Wisconsin Department of Transportation

Proposal #06: 1060-27-71, WISC 2025596
I-94 East West, West Leg
70th Street to Zablocki Drive
IH 094
Milwaukee County

This is Addendum No. 01, which provides for the following:

ADDENDUM NO. 01

Addendum No. 01
ID 1060-27-71
Revised Sheet 31
August 25, 2023

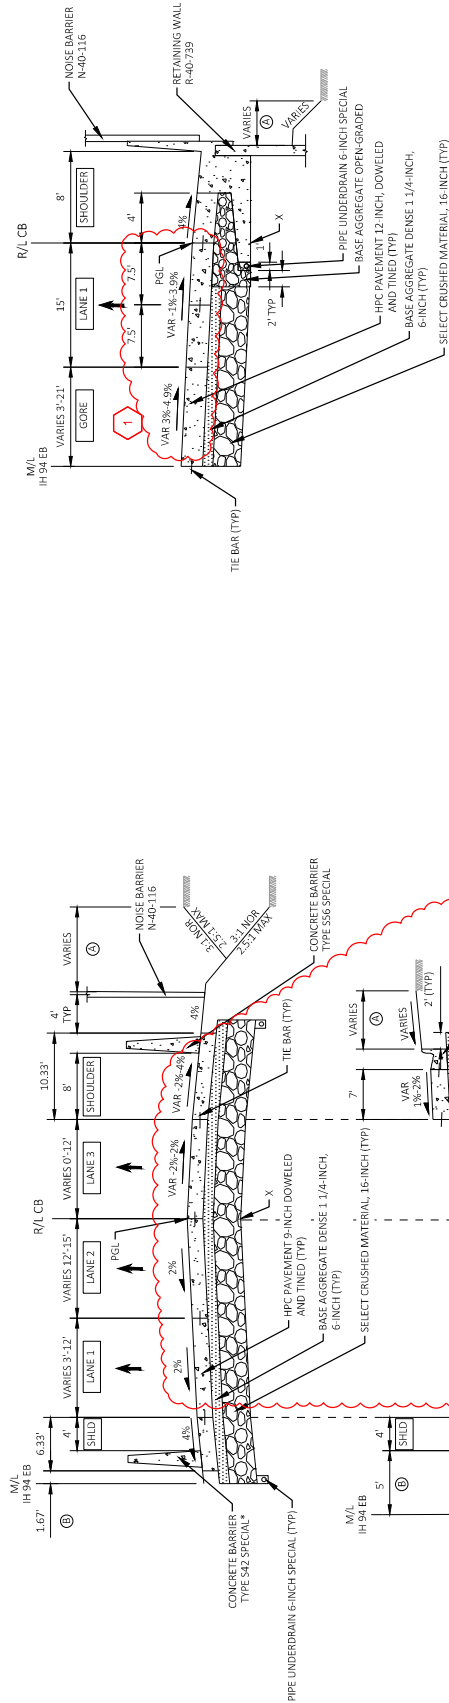
Revised Plan Sheets	
Plan Sheet	Plan Sheet Title (brief description of changes to sheet)
4	General Notes: Updated utility contacts
31-34	Typical Finished Sections: Adjusted jointing and cross slope ranges
51	Construction Details: Added detail for S32 Special barrier
64	Construction Details – Drainage: Modified detail for vane drain at reverse footing barrier
126-127	Removal Plan: Added milling to east end of project
467-468	Signing Plan – Permanent: Changed Bike Route signs to Bike Lane signs
471	Signing Plan – Permanent: Changed Bike Route signs to Bike Lane signs
622	Pavement Marking: Added items to legend
629-633	Pavement Marking: Removed grooving from markings between cemeteries and extended pavement marking limits
670	Traffic Control Overview – Stage 1A: Changes staging note
671	Traffic Control – Typical Sections: Updated work limits and pay items
686	Traffic Control Overview – Stage 1B: Showing work done in prior stage

Addendum No. 01
ID 1060-27-71
Added Sheet 74A
August 25, 2023

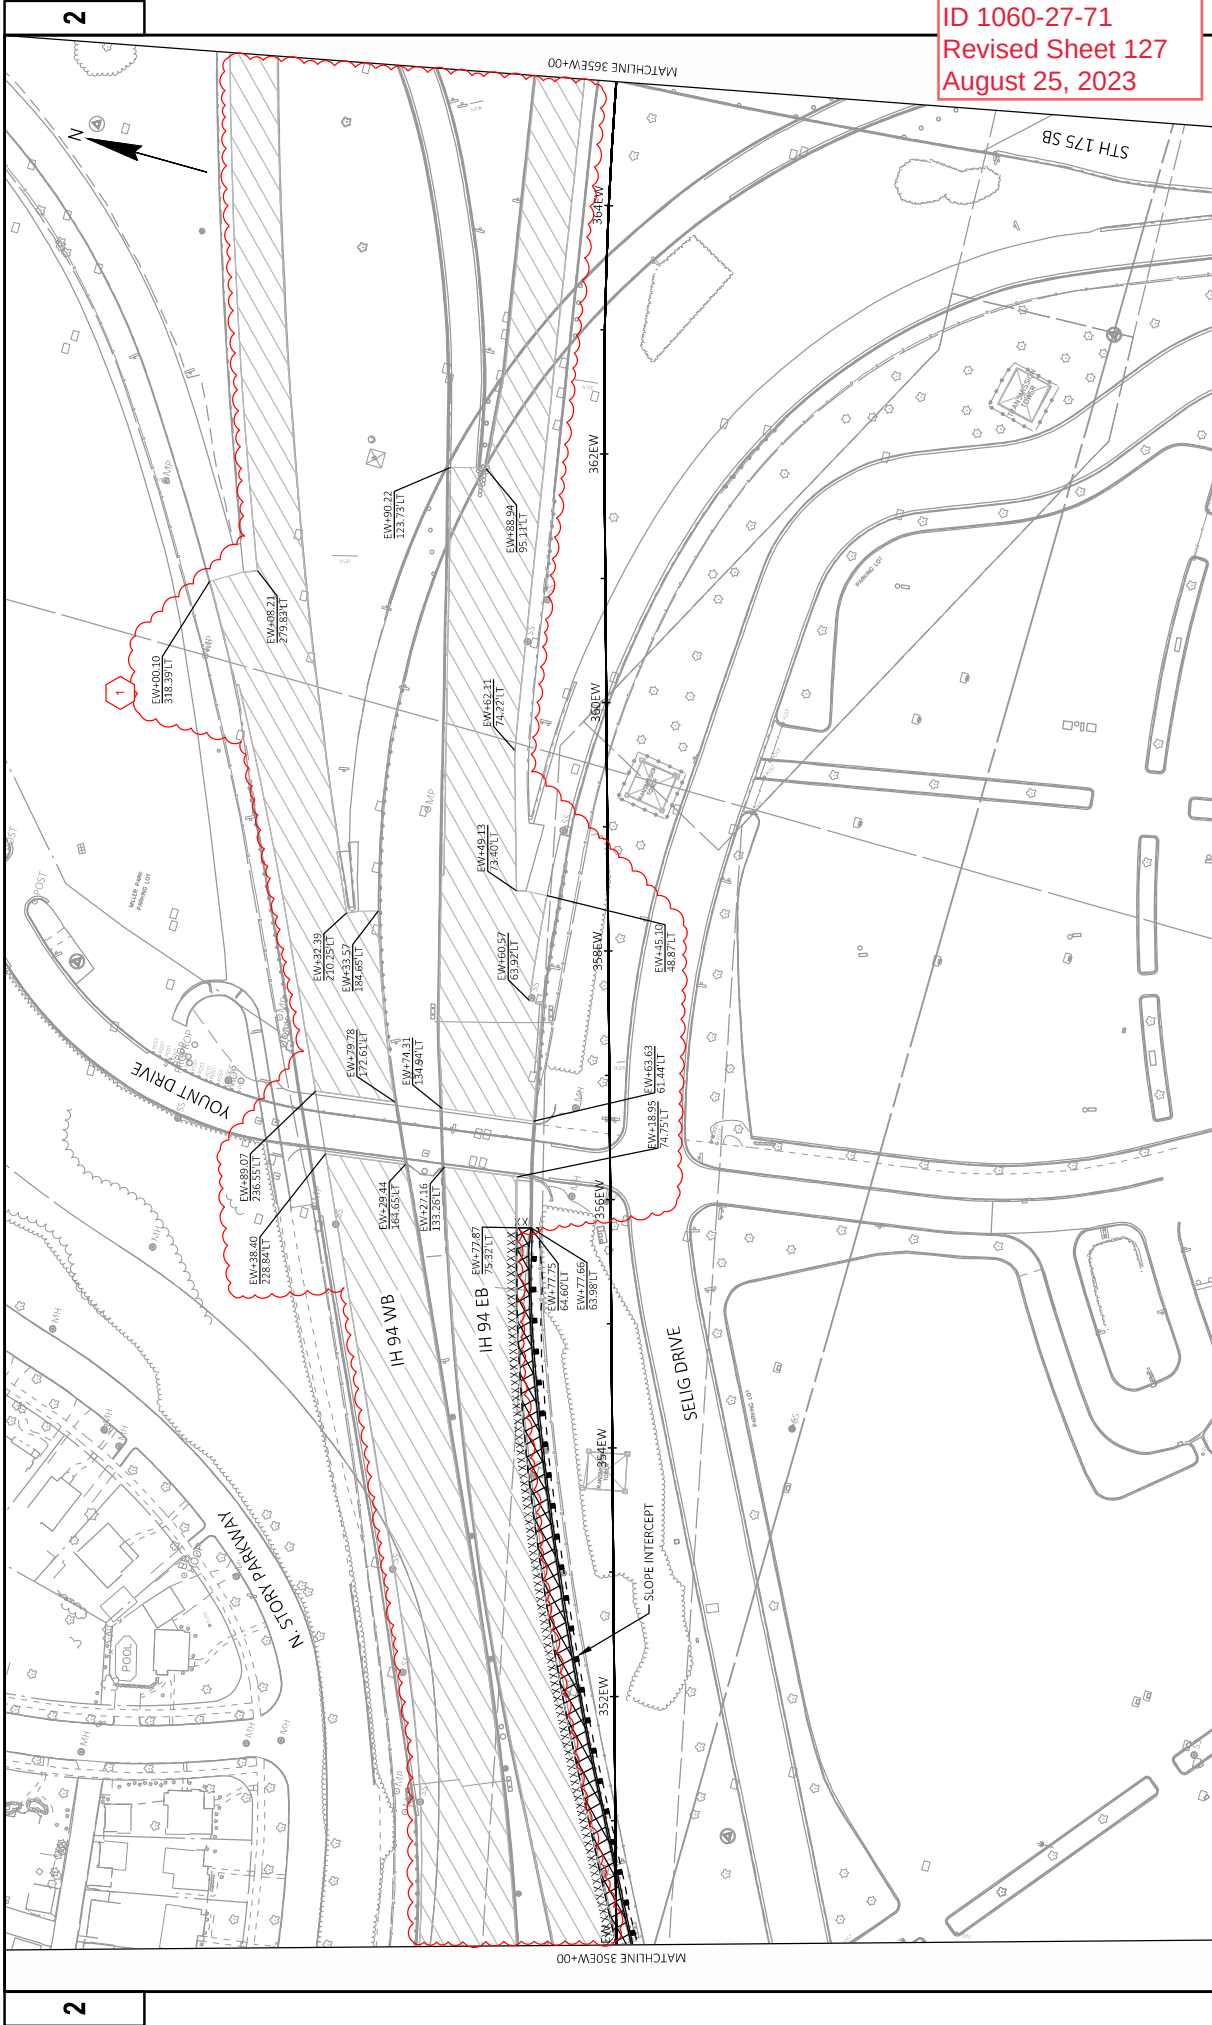
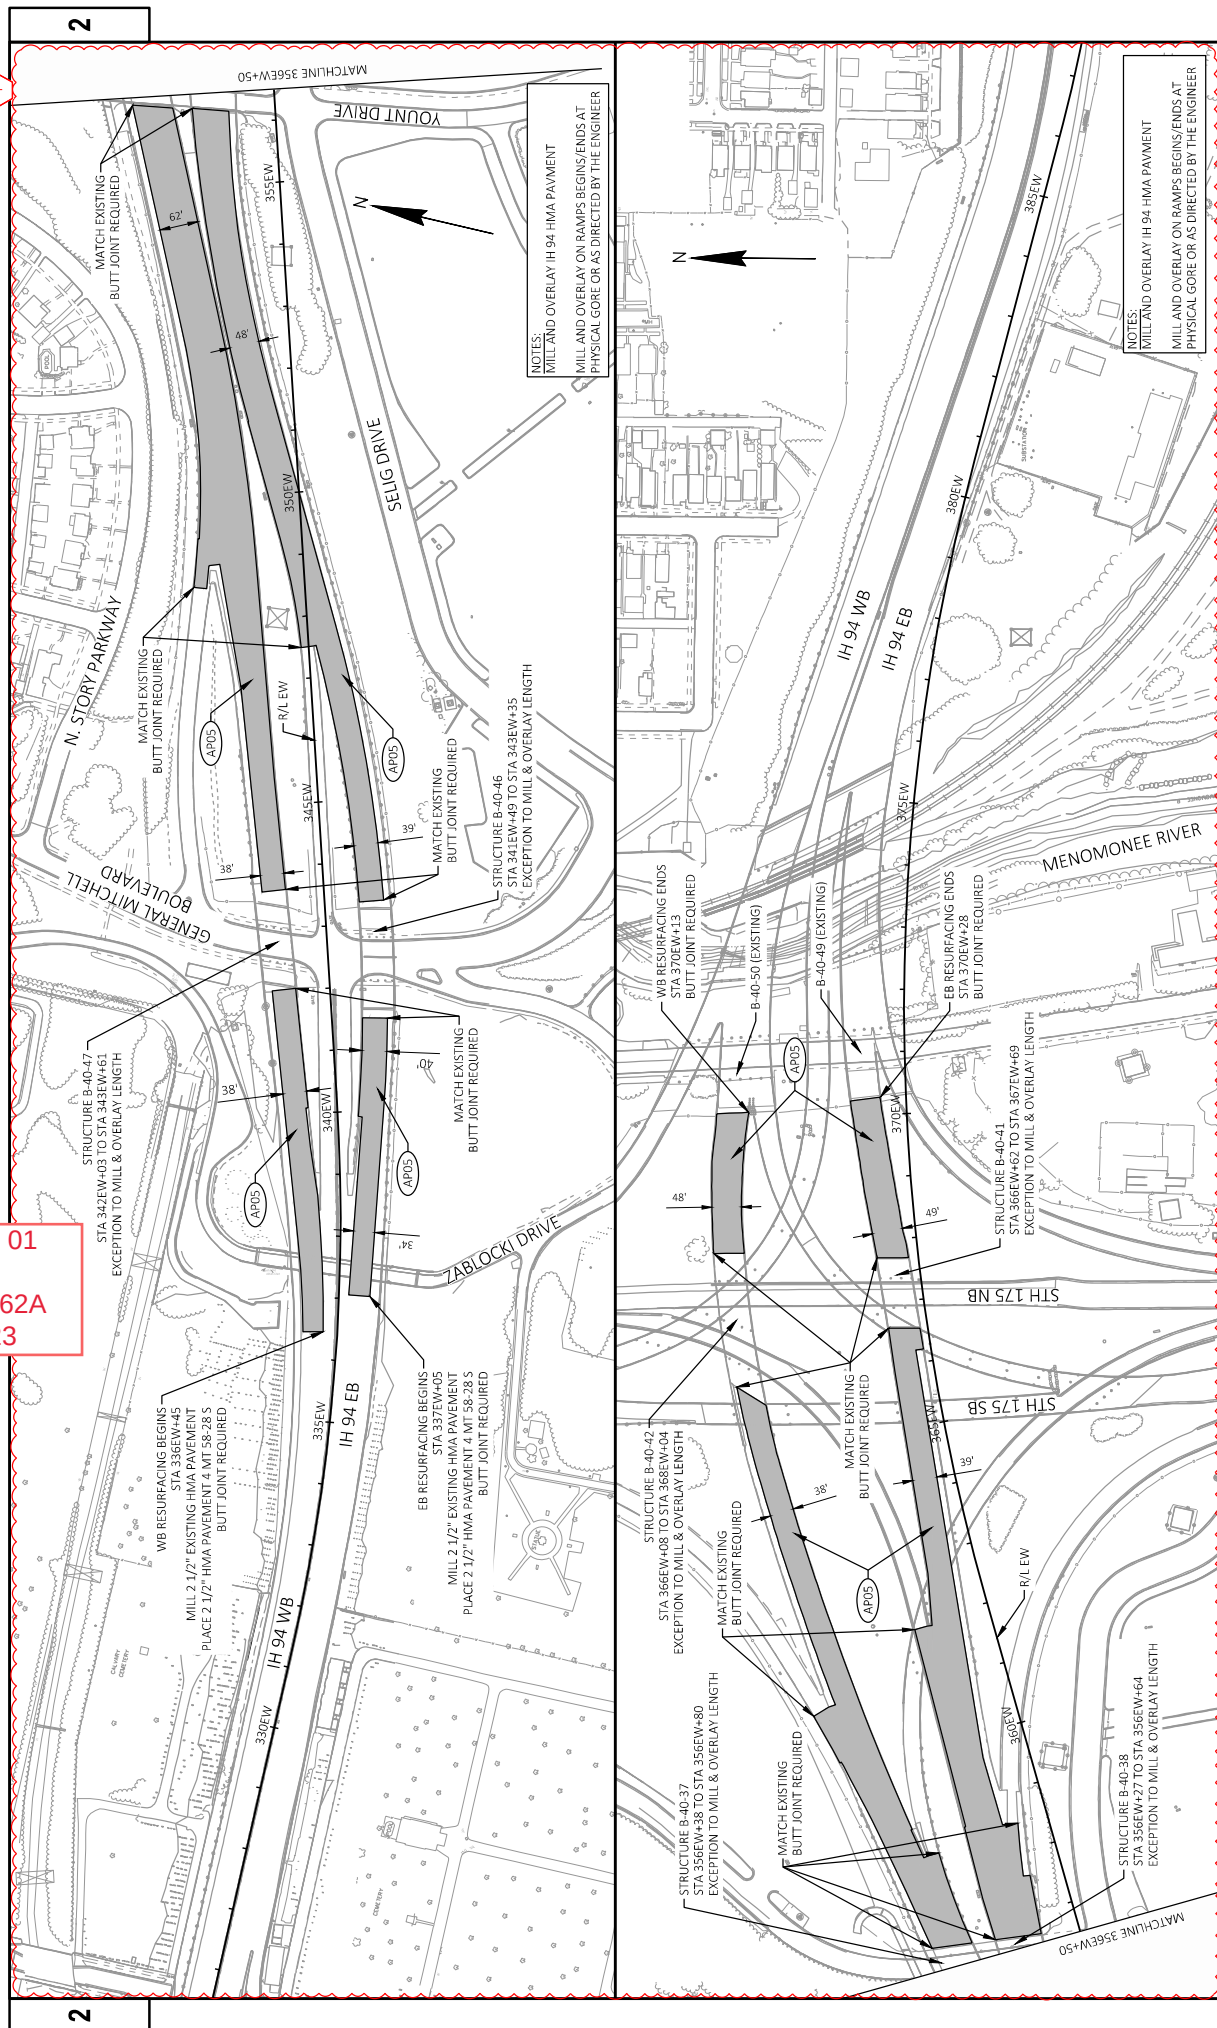
Added Plan Sheets	
Plan Sheet	Plan Sheet Title (brief description of why sheet was added)
39A	Typical Sections: Added Typical Sections for additional clarity
74A	Construction Details: Added butt joint detail
127A	Removal Plan: Added milling to east end of project
162A	Plan Details: Added sheet for mill and overlay
762A	Traffic Control – Typical Sections: Added Stage 3B Typical Sections

DESIGNED BY	JRM
CHECKED BY	AMR LKD
DATE	8/21/25
SCALE	1:10
SHEET	1 OF 10
GENERAL PLAN & ELEVATION (1 OF 2)	2110

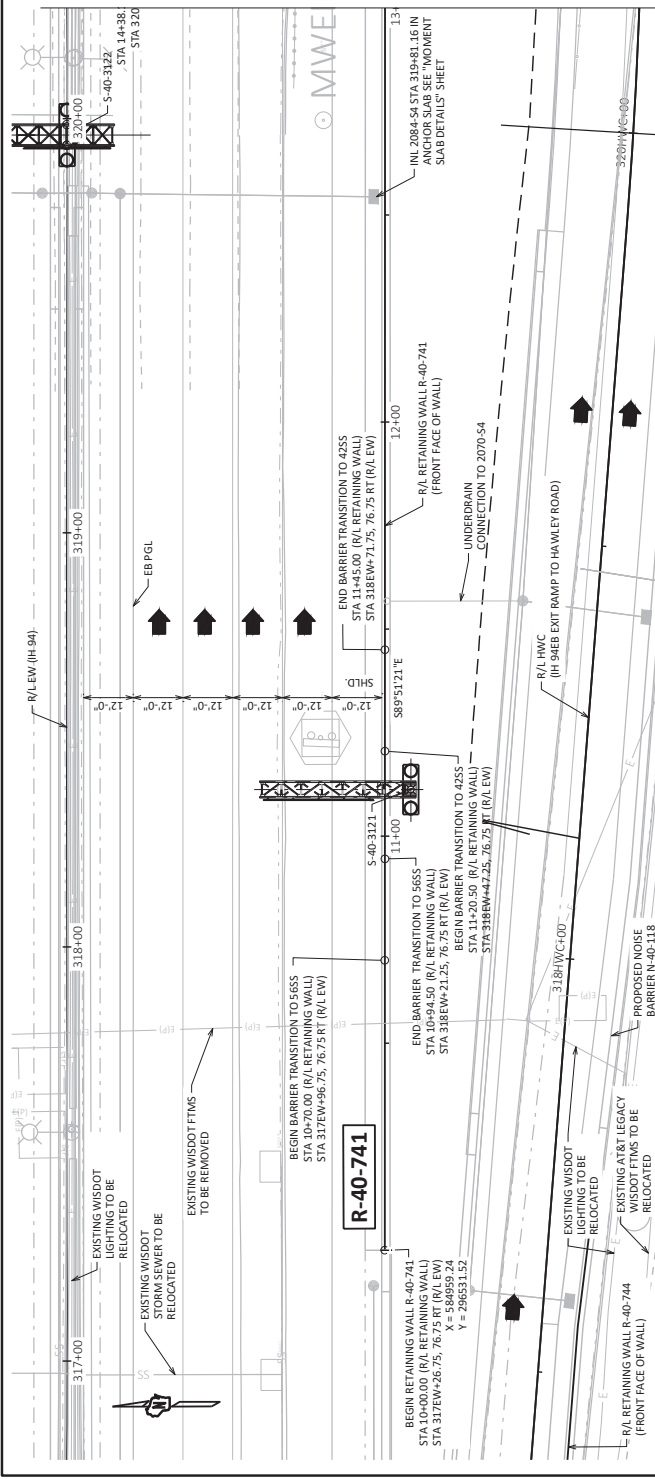
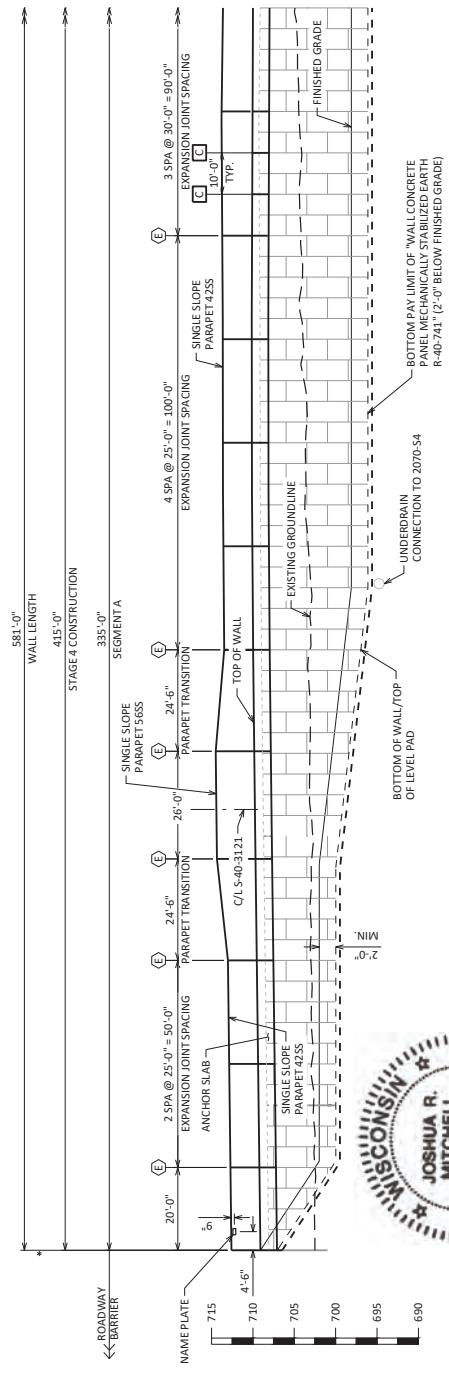
768-770	Traffic Control – Stage 3A: Changed notes for work done in prior stages
837	Detour – Regional Alt Route: Added state furnished sign locations and note
912	Misc Quantities: Added milling quantity
960-961	Misc Quantities: Adjusted pavement marking quantities and added items
977	Misc Quantities: Changed Bike Route signs to Bike Lane signs
979	Misc Quantities: Changed Bike Route signs to Bike Lane signs
981	Misc Quantities: Changed Bike Route signs to Bike Lane signs
1148	Misc Quantities: Added State Furnished Sign table
1158	Misc Quantities: Changed Bid Items for Temporary Asphalt Overlays and Widening
1161	Misc Quantities: Changed Traffic Control Temp Marking Line Epoxy quantity
1165	Misc Quantities: Changed Traffic Control Temp Marking Line Epoxy quantity
2110	Structure R-40-741: Removed note limiting wall panel size
2112	Structure R-40-741: Modified Wall External Stability Evaluation table
2120	Structure R-40-742: Removed note limiting wall panel size

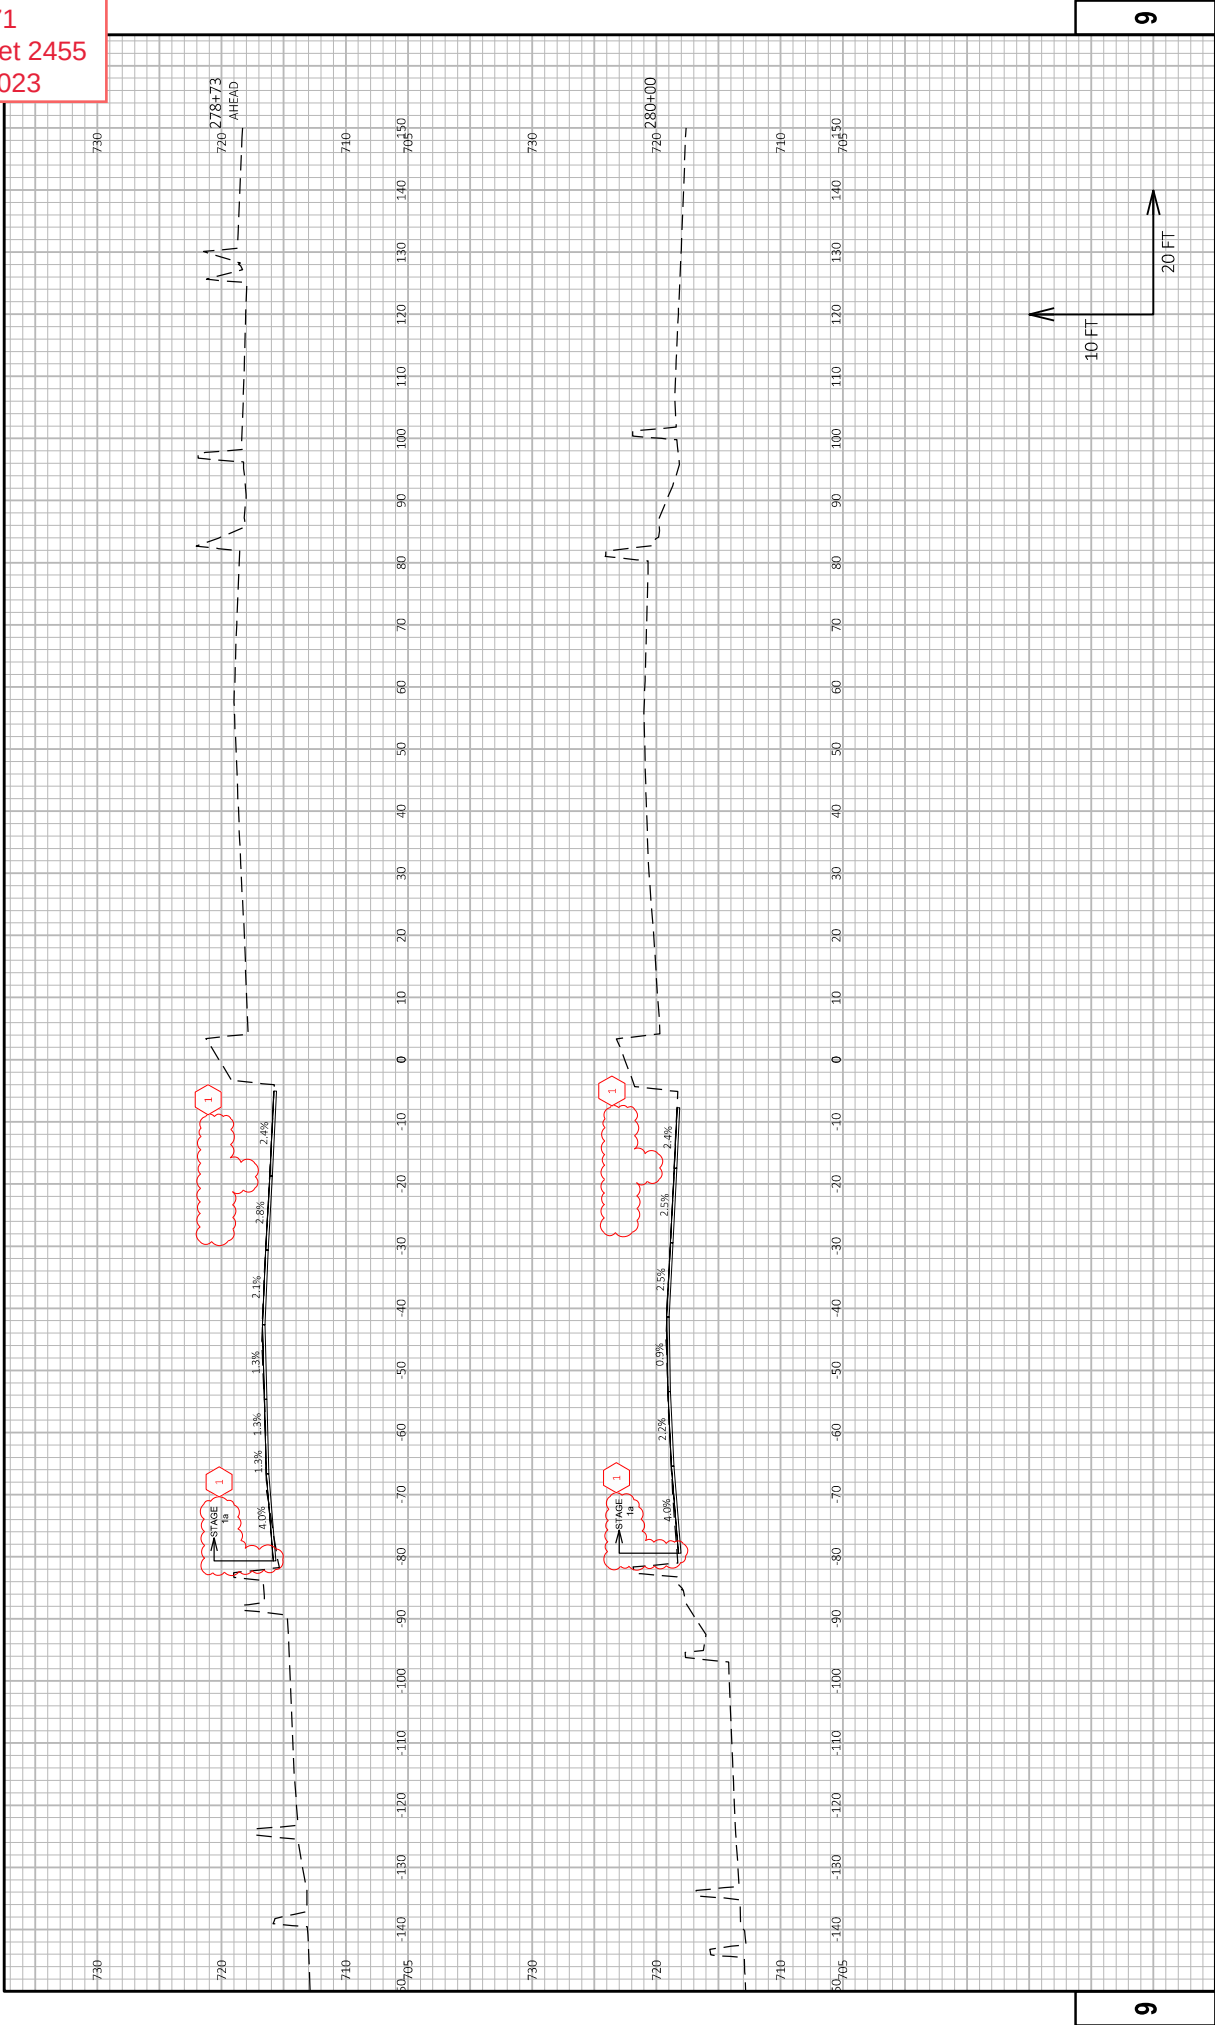
2143	Structure R-40-762: Removed note limiting wall panel size
2455-2481	Cross Sections – IH 94 Temporary: Changed staging ticks
